Standards Update Transmittal

Reference Number: 2024v-13
Standards: Standard Drawing: L-21, L-22, and ST-45
Improvement Standards: 4.18

L - 21

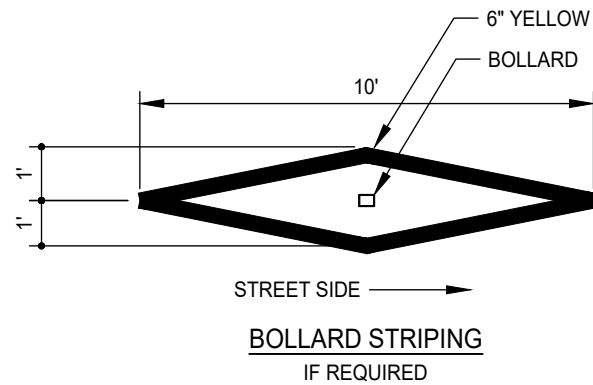
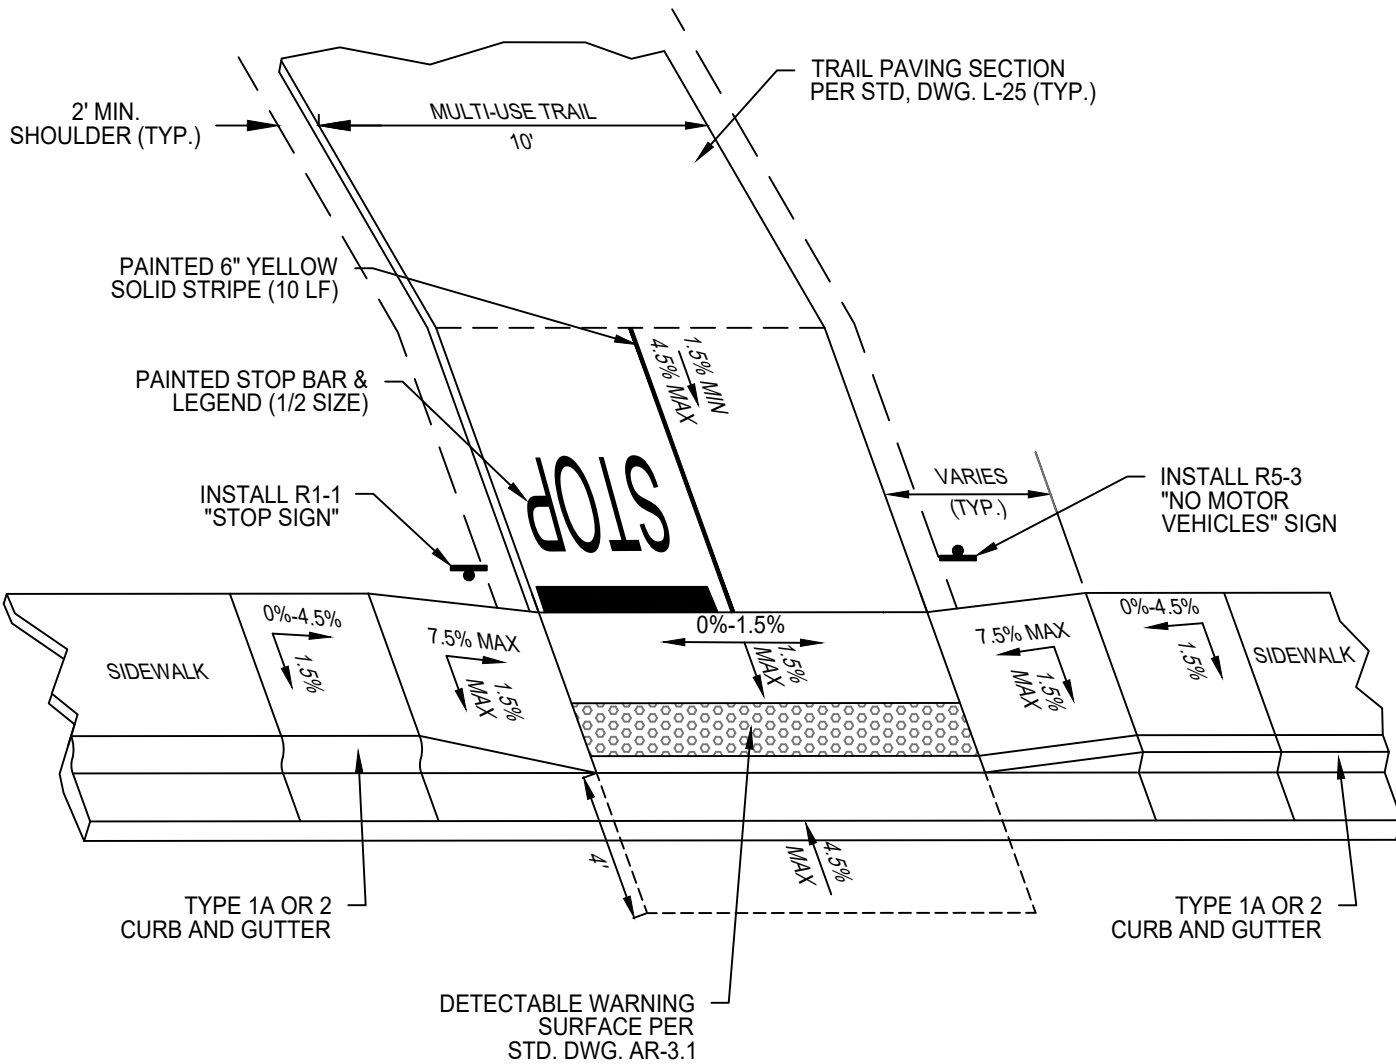
1. Modification to Standard Drawing:
 - a. L-21 KNOCK-DOWN BOLLARD AND STATIONARY BOLLARD, delete knock-down bollard detail to create L-21 for stationary bollard detail only.
 - b. L-22 REMOVABLE BOLLARD, delete standard.
 - c. ST-45 MULTI-USE TRAIL CONNECTION AT MID-BLOCK CROSSWALK, remove detail for knock-down bollard and diamond striping. Increase 4" yellow solid stripe to 6" stripe.
2. Modification to Improvement Standard:
 - a. 4.18 PEDESTRIAN LANES AND TRAILS, remove reference to Standard Drawing detail L-22 as it has been deleted.
